# Meeting 7+8

# Comment Discussion

Huawei Technologies Canada

P802.3ck Chief Editor

Figure 120G-2—100GAUI-1, 200GAUI-2, and 400GAUI-4 C2M insertion loss budget at 26.56 GHz

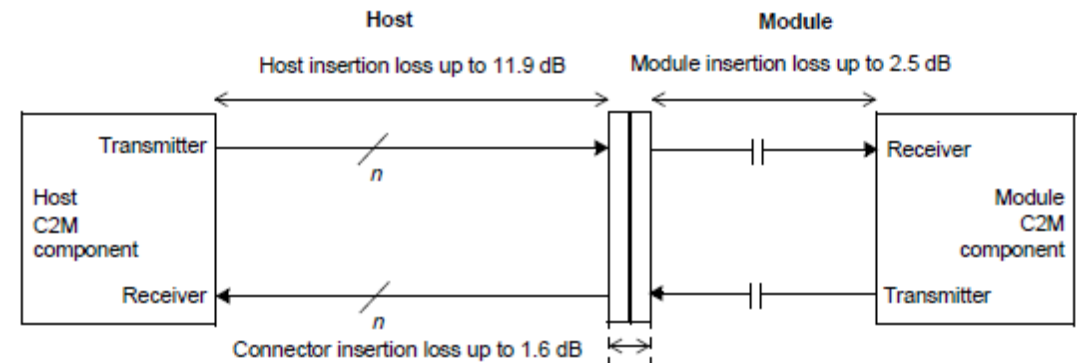
The figure shows a host insertion loss of up to 11.9 dB, but in 120G.3.4.1.1 (module stressed input procedure) one of the test cases has 18.2 dB insertion loss, which "represents 16 dB channel loss with an additional allowance for host transmitter package loss". The informative graph at 120G.4.1 also looks like 16 dB.

Likely, change the value in the figure to 16 dB.

PROPOSED REJECT.

120G.3.4.1.1 (P232/L8) refers to the channel IL, which is from host transmitter to module receiver including the transmitter package, as opposed to the host IL.

In Figure 120G-2, the channel loss, which is a sum of the section losses, is 16 dB.

It seems that the commenter has misinterpreted the diagram.

16 dB is loss from host TX to module RX

$11.9 + 1.6 + 2.5 = 16 \text{ dB}$
